TOWN OF CARMEL
PLANNING BOARD

PLANNING BOARD AGENDA
JANUARY 25, 2023– 6:00 P.M.

RE: **CRO-534: West Branch Reservoir Auxiliary Dam (Putnam County)**
New York City Department of Environmental Protection
Bureau of Engineering, Design and Construction
Slope Improvements Project
Town of Carmel Site Plan Approval Application

DATE: 9/5/2022
SCALE: 1"=50'
SHEET NO.: 4 OF 49
DRAWING NO. G-004.00

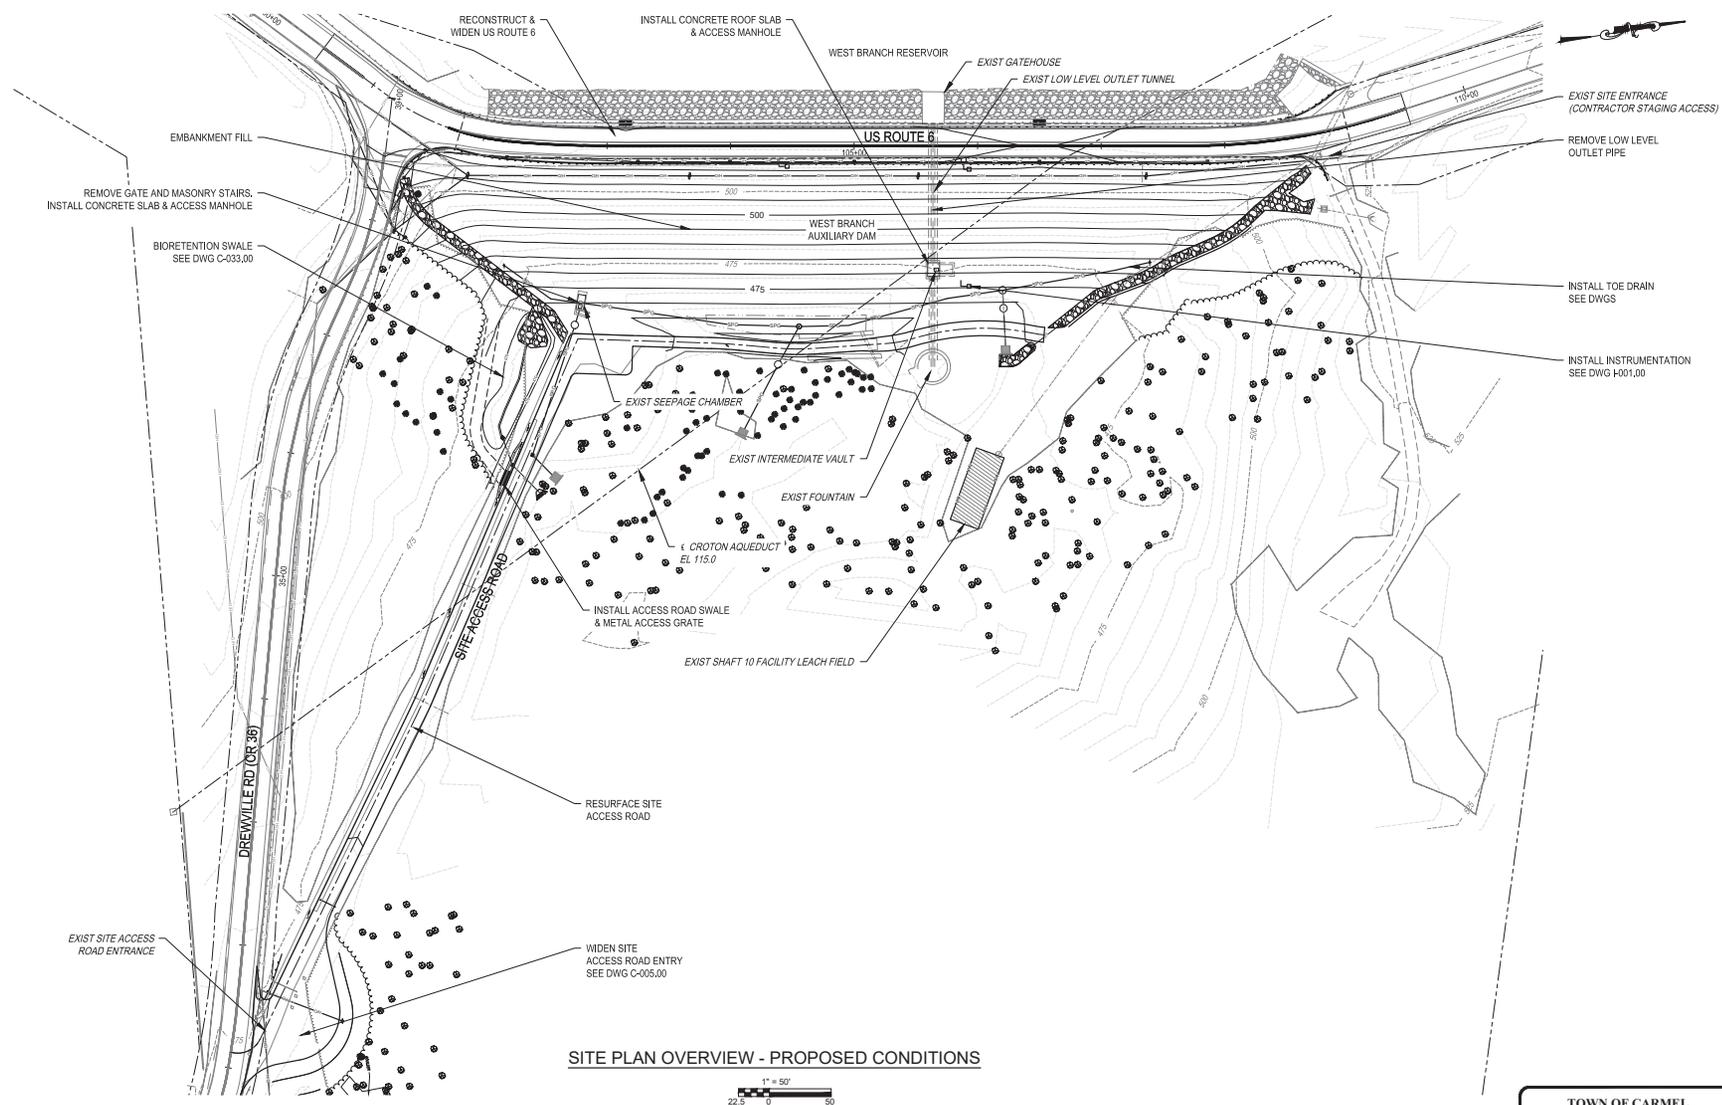
Comment 5: Work along existing access road must have a stabilized construction entrance.

Response 5: As shown on Sheet G-004.00 construction access roads already exist on the northwest and southeast corners of the site and are the primary construction access points for the Contractor. A stabilized construction entrance is shown on Sheet C-42 on the northeast side of Route 6. A stabilized construction has been added to Sheet C-43 to support the access road located from Drewville Road. The stabilized construction entrance shall be constructed in accordance with Detail F on Sheet C-48.
